Subject: CONTRACT CHANGE ORDER #1:
Meadowbrook Golf Course – North Well Redrill
Contractor: Van Con Construction, Inc.
Contract No: PAR81057

PROPOSAL REQUEST

PROJECT: Meadowbrook GC North Well 4197 S 3100 W. Taylorsville, UT 84123	PROPOSAL REQUEST NO.: 1
TO CONTRACTOR: VanCon Inc. 1825 N. Mountain Springs Pkwy Springville, UT 84663	COUNTY CONTRACT NO.: PAR81057

CIVIL
 SITE & UTILITY PLAN
 DRAWING NO. C-03
 SHEET 08 OF 14

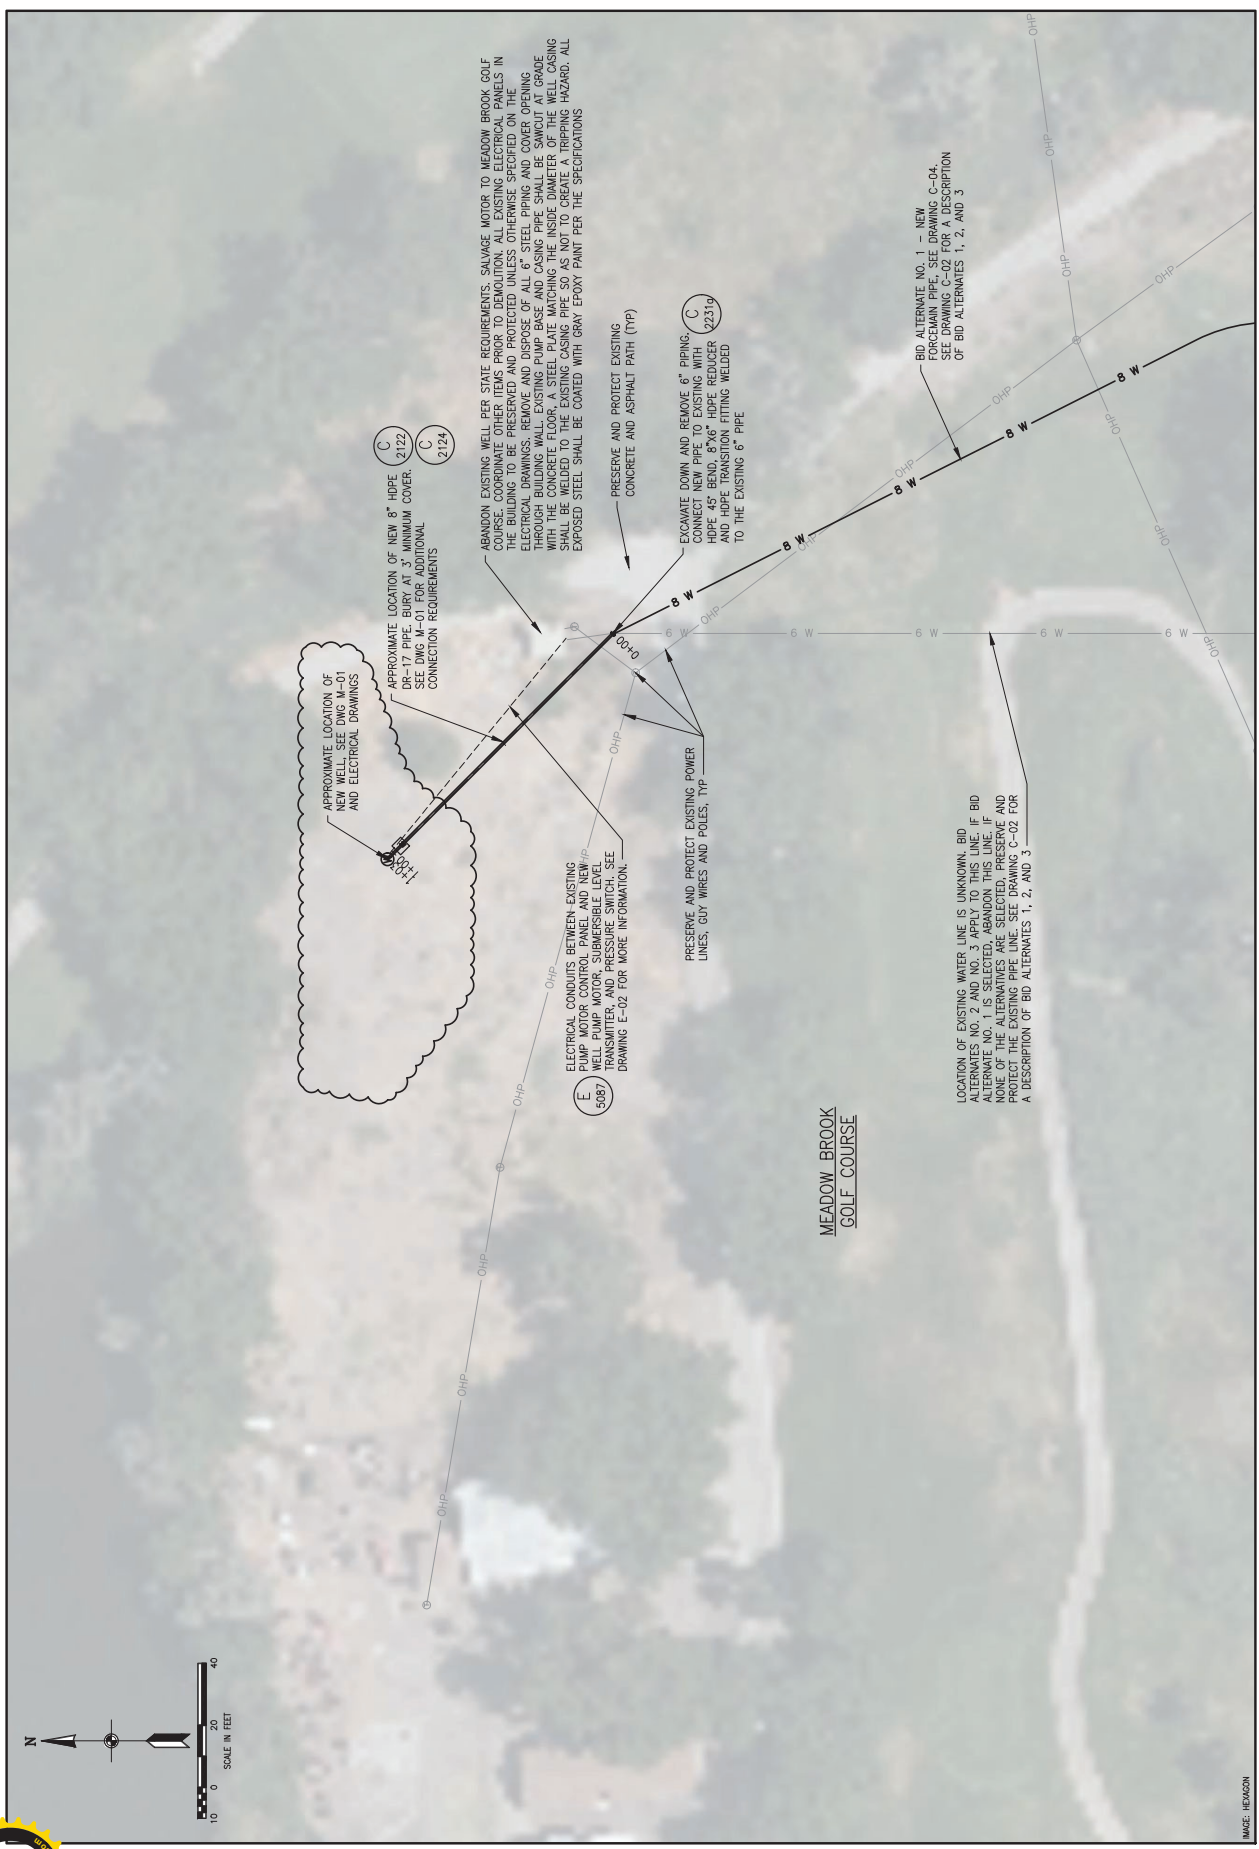
Item 2: The Contractor is directed to cast-in-place a 7' square vault around the new well head, with a gravel base, and backfill against the vault and hold the backfill with a boulder retaining wall. Also, install a well drain, a new water-tight well head, air valve ports, pump motor cable, sounder tube, a flow meter, and a discharge pipe as reflected in the revised project drawings, C-03, GC-02 and M-01.

After reviewing the current artesian conditions at the well head, we would like to adjust the construction of the well head. The design changes include; removing the 4'x4'x5' concrete valve vault; removing the pitless adapter; removing the bollards; installation of a new 7' square vault around the new well with gravel support; installation of a well drain; installation of a new water-tight well head; ports for air valve, pump motor cable, sounder tube, and discharge pipe; placing fill and boulders around vault; and all other improvements shown on the attached document.

The discharge end of the pipeline into the pond has been adjusted to bring the pipe above grade and a flow meter added.
